Lr. No. RPP-SM-JV/RRW/457

Project: Major up gradation of Raipur Railway Station of SECR on Engineering Procurement and Construction (EPC) mode.

Subject: Re-Submission of Architecture Definitive Drawings for the Rear side Station Building 1-A.

Vide ref AE's Lr No: TL-PMS/RPPS/240 dt 10-05-2025, we are re-submitting Definitive Drawings for the Rear Side Station Building 1-A.

ELEVATION A

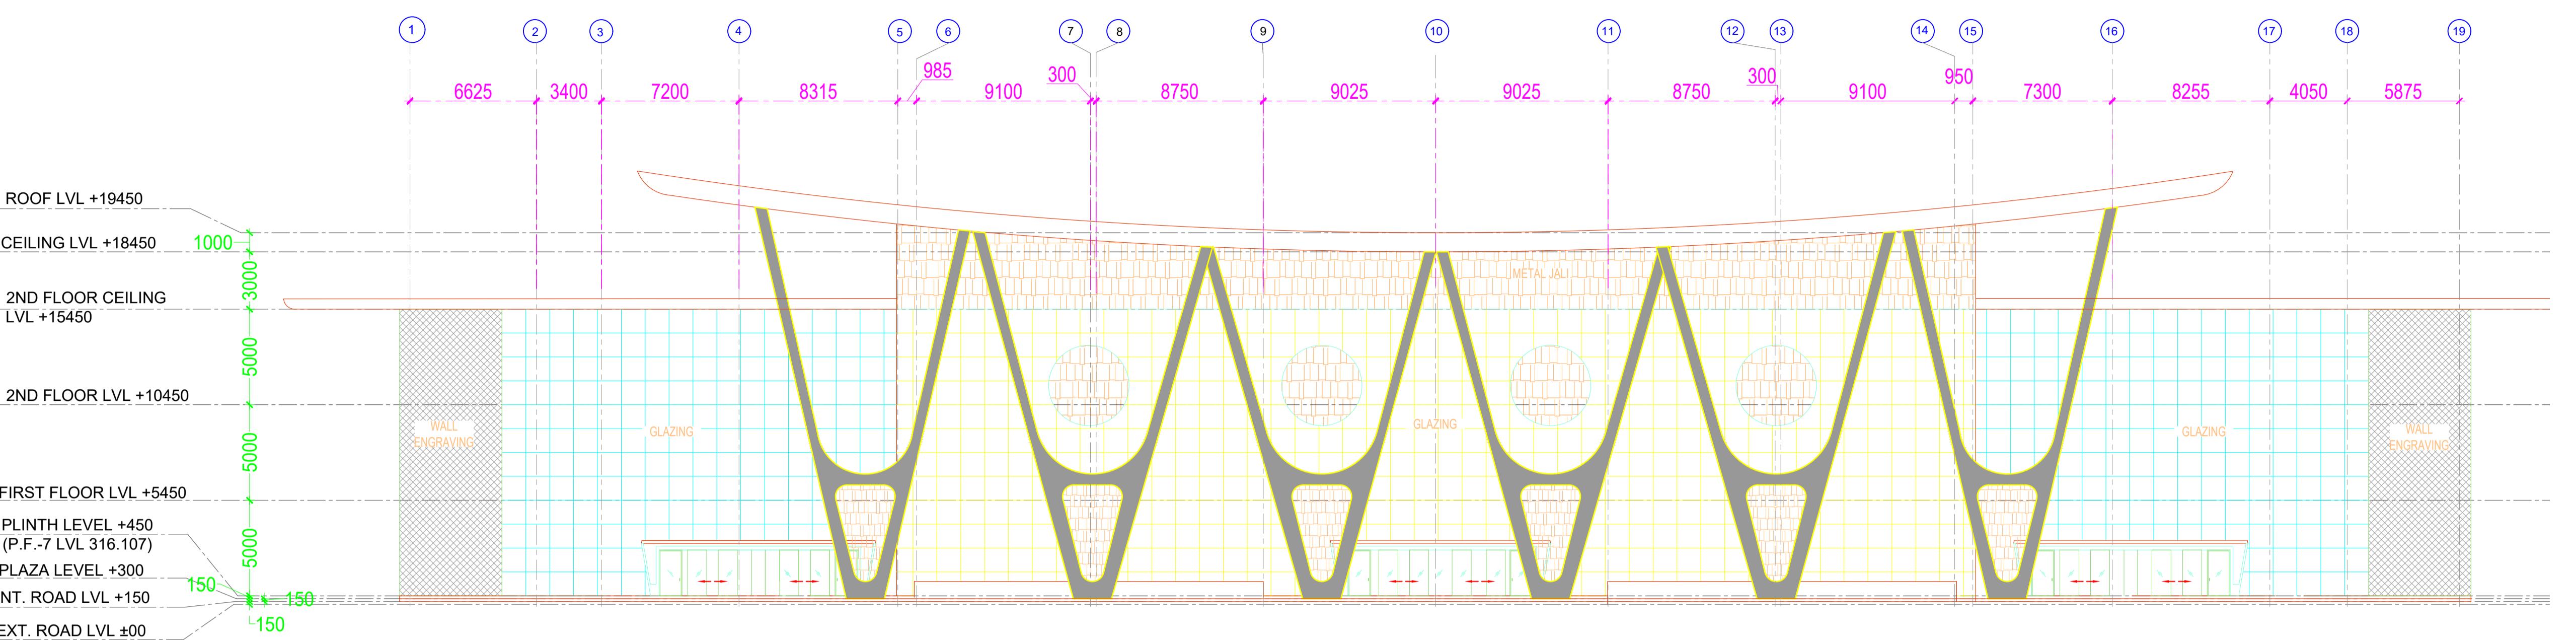
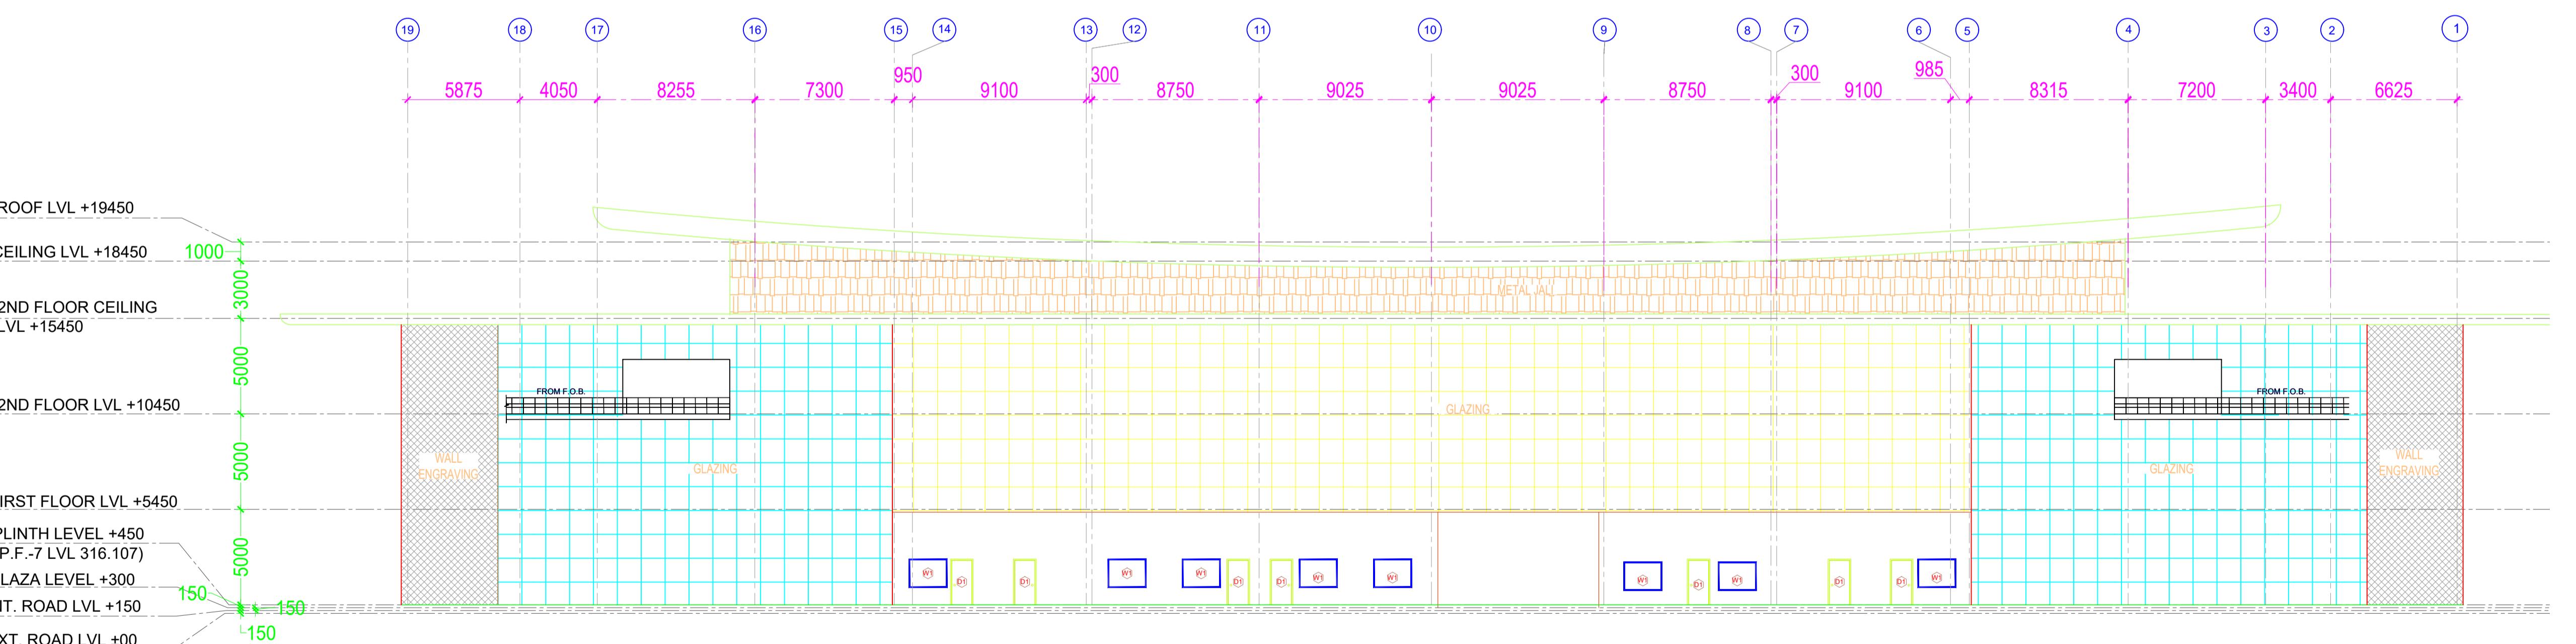
d. Do provide description of elements/members for façade elevation.

v. Number of architectural façade columns to be as per approved GAD.

REPLY: Yes, we have already incorporated the same.

REPLY: In GAD there are total 4 no. façade column where as in Tender 3D

there are 6 no. façade column which we have followed. Please update which 1 to follow we will update it accordingly.
